# PERMIT

**Tax ID # 05-451531**  
**ON-SITE SEWAGE DISPOSAL SYSTEM**  
**HOWARD COUNTY HEALTH DEPARTMENT**  
**BUREAU OF ENVIRONMENTAL HEALTH**

SUBDIVISION: The Oaks at Bridal Creek LOT NUMBER: 5

ADDRESS: 5034 Green Bridge Road PROPERTY OWNER: Jeff and Bhakti Harp

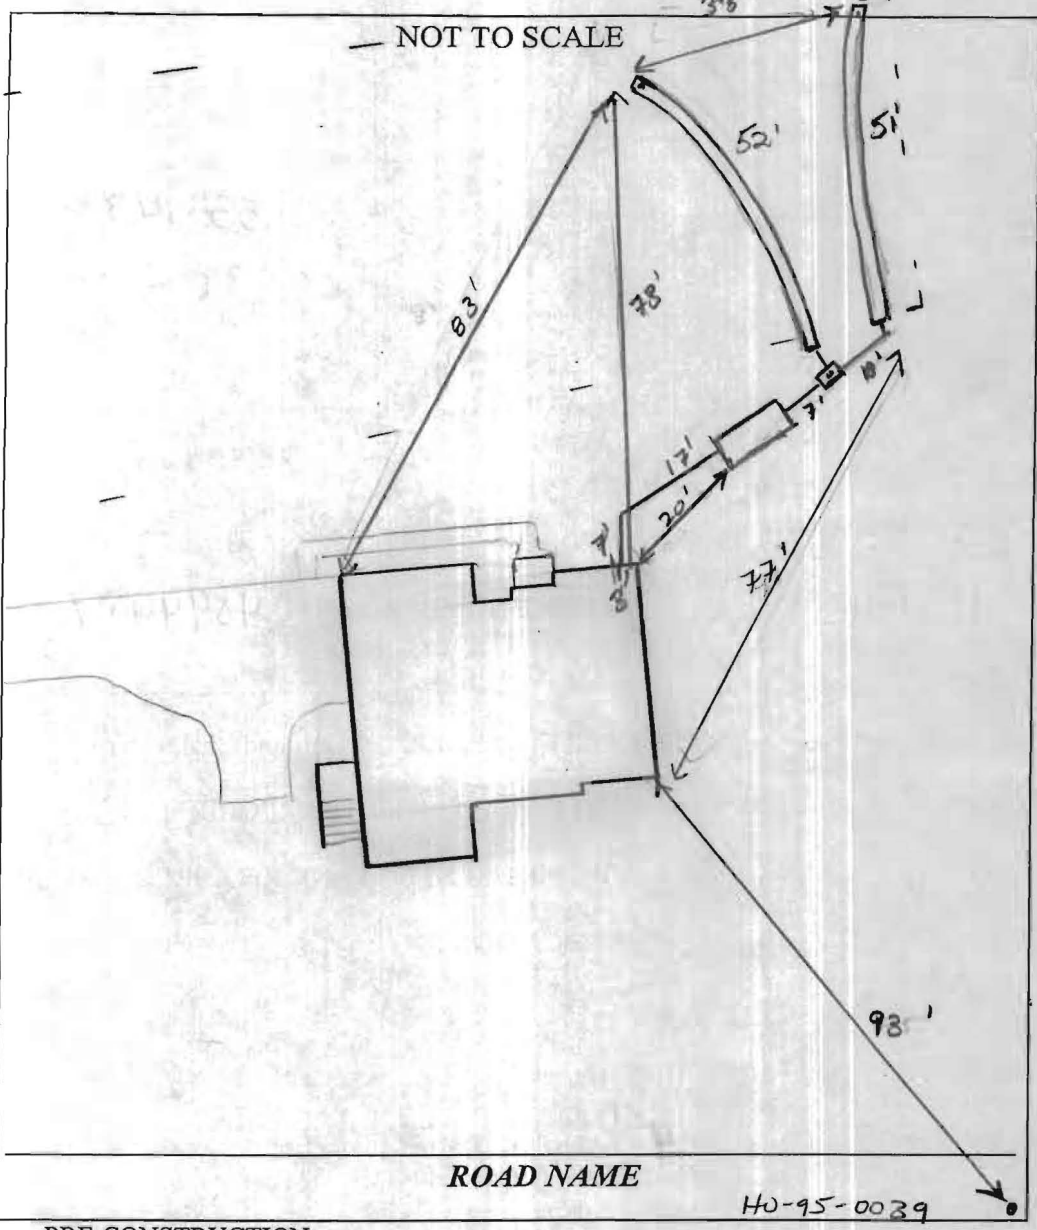
8/15/11 Layout cancelled per phone call w/ contractor due to heavy rains (KW)  
 8/16/11 SRA not staked. (KW)  
 8/22/11 Set tank 20' from dwelling, install 2x52' trenches as pointed out in field. start @ high corner of SRA running out across SRA towards road access. (KW)

8/24/11 Contractor installed second (lower) trench not as directed during layout. Should be OK. Soil looks good. Plenty of SRA. OK to cover all work (KW)

**FOUNDATION LOCATION DRAWING**  
**OAKS AT BRIDLE CREEK**  
**LOT 5**  
**5034 GREEN BRIDGE ROAD**  
 PLAT: #19909  
 DEED REFERENCE: 11117/68  
 TAX MAP 28 GRID 7 PARCEL 13  
 5TH ELECTION DISTRICT HOWARD COUNTY, MD  
 SCALE: 1"=50' DATE: MAY 3, 2011  
 DATE OF LATEST FIELD WORK: 5/3/11

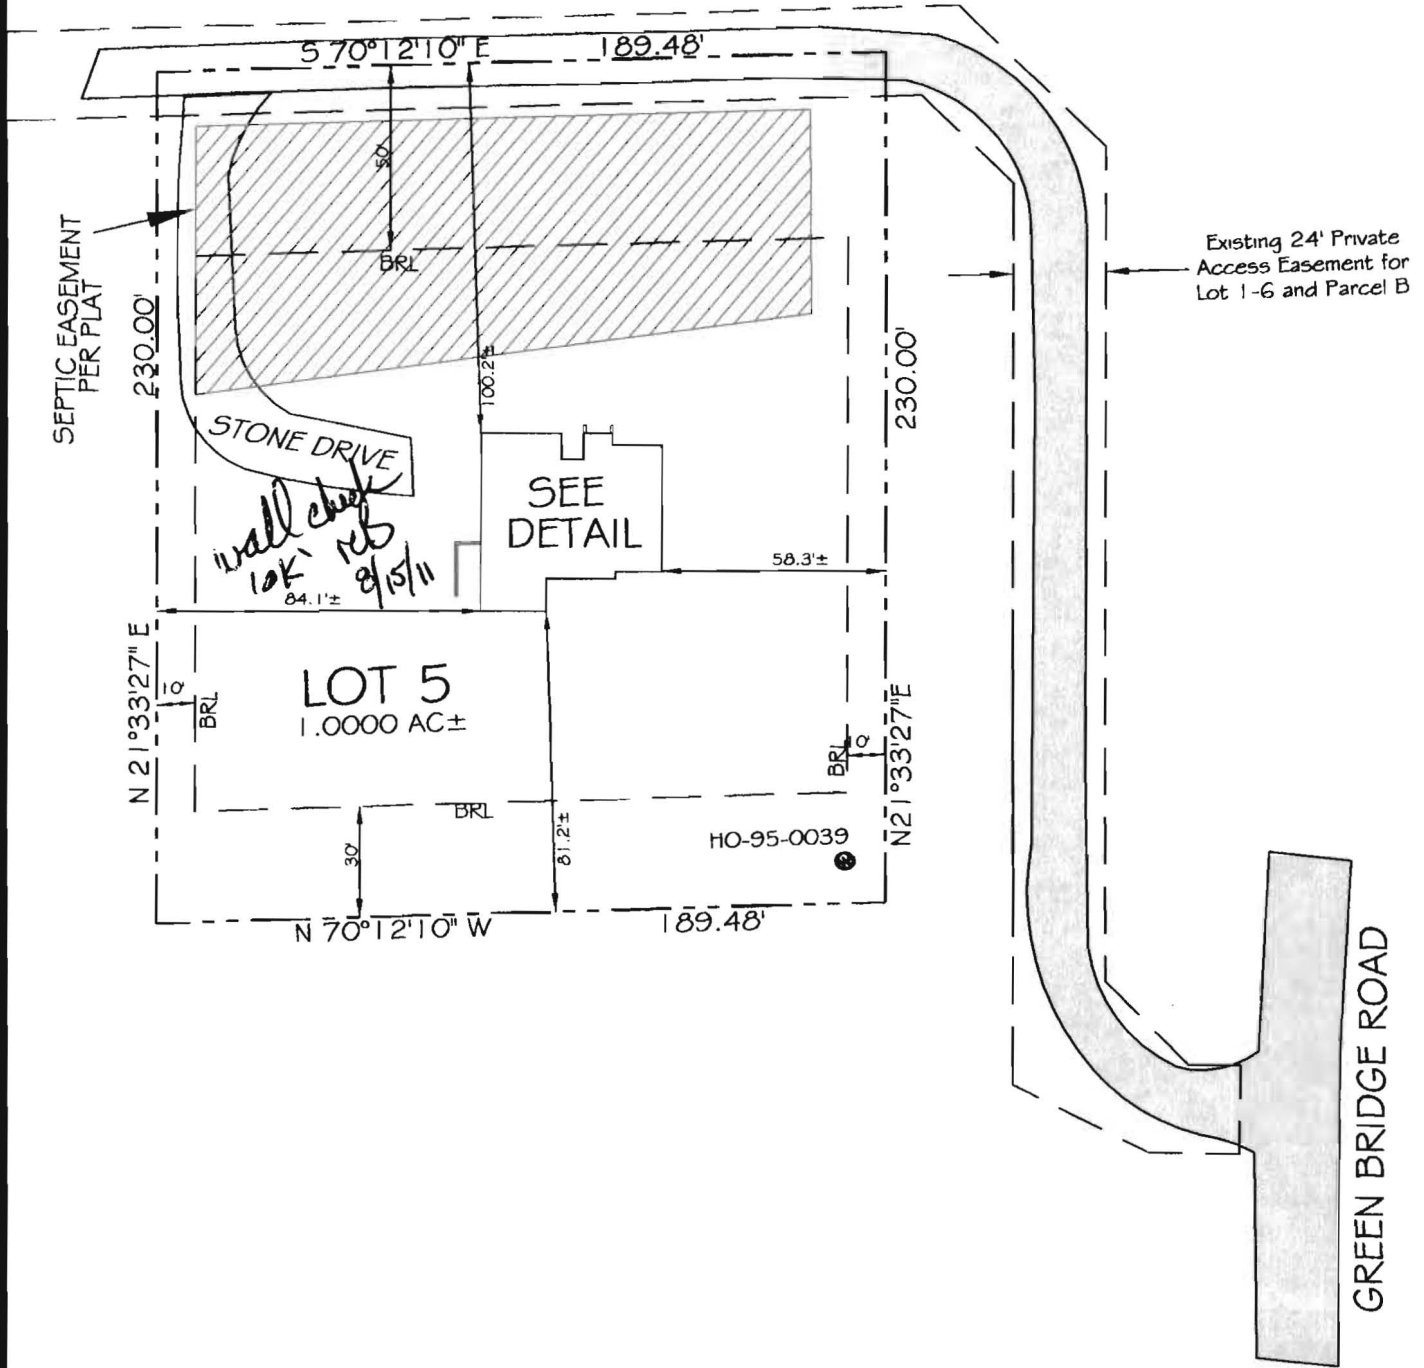
Per our conversation I am requesting a Septic Reserve waiver to adjust the Septic Reserve Area at 5034 Green Bridge Road, Dayton, MD (Lot 5) to allow a driveway on the west property side. The current estimated Septic Reserve Area is 10,322 SF. The final Septic Reserve Area will remain more than 10,000 SF. The adjustments will include expanding the Septic Reserve Area 10 feet east by eliminating the driveway. This would allow for a 10 foot reduction of the Septic Reserve Area on the west side. Currently, there exists a 10 foot set back from the property line. The driveway will begin 8 feet from the property line and will encroach a total of 10 feet into the Septic Reserve Area. A new drawing is not required as a waiver will be sufficient.

The Health Department received your waiver request via email on February 8, 2011 for the above referenced property to allow the driveway to encroach ten (10) feet into the sewage disposal area (SDA). The Health Department grants **approval** of the waiver and shall not require a revised perc certification plan based on the fact that current estimated SDA is 10,322 square feet, which is 322 square feet more than required by the *Code of Maryland Regulations*. Furthermore, if additional area is ever needed the SDA could be extended 10 feet to the east where the driveway was initially proposed on the perc certification plan signed by the Health Department on May 17, 2005. A driveway location on the building permit plot plan other than described in this letter will require additional review by this Department.
